UNITED STATES PATENT AND TRADEMARK OFFICE

APPLICATION NO.	FILING DATE	FIRST NAMED INVENTOR	ATTORNEY DOCKET NO.	CONFIRMATION NO.
10/811,179	03/26/2004	Naoki Katayama	004553.108040	2023
29540	7590	07/12/2006	EXAMINER	
PITNEY HARDIN LLP 7 TIMES SQUARE NEW YORK, NY 10036-7311				UHLENHAKA, JASON S
		ART UNIT		PAPER NUMBER
				2853

Office Action Summary	Application No.	Applicant(s)	
	10/811,179	KATAYAMA, NAOKI	
	Examiner	Art Unit	
	Jason Uhlenhake	2853

DETAILED ACTION

FIG. 4

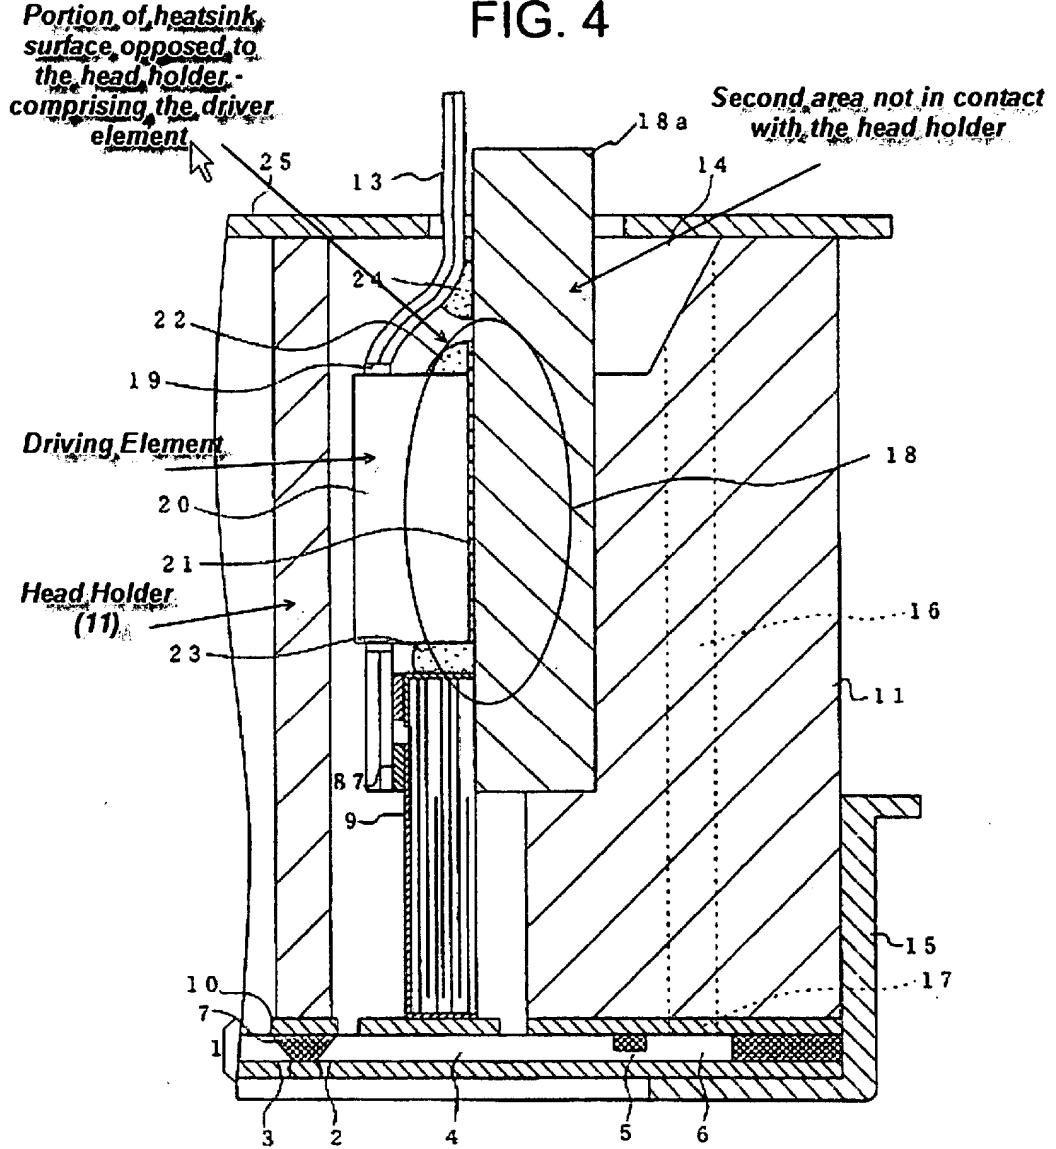
Regarding claim 14, Kimura does disclose "a portion of the surface of the heatsink to be opposed to the head holder, which portion comprises a first area corresponding to the driver element and a second area surrounding and adjacent to the first area, is **not** in contact with the head holder" as claimed by the applicant, please see the following figure 4 of Kimura.

Fig. 13

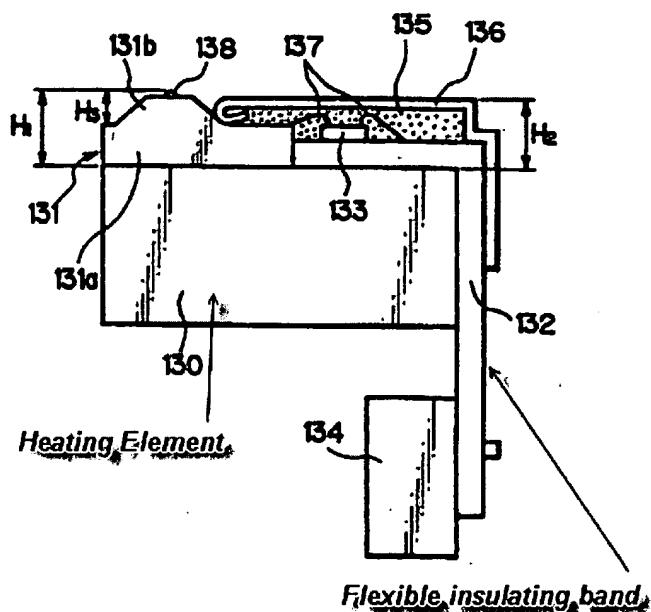
Regarding claim 2, Kimura et al (6,386,672) in view of Yamada et al (U.S. Pub. 2002/0105567) and Shiraishi et al (U.S. Pat. 5,428,373) discloses that the heatsink is directly held in close contact with a surface of the flexible insulating band which surface is opposite to another surface of the flexible wiring board insulating band on which the driver element is disposed. Figure 13 specifically shows the flexible insulating band in close contact with a

heatsink (Shiraishi et al; Column 4, Lines 25 – 38; Column 13, Lines 55 – 68), for the purpose of electrically connecting the electrical structure with an external circuit.
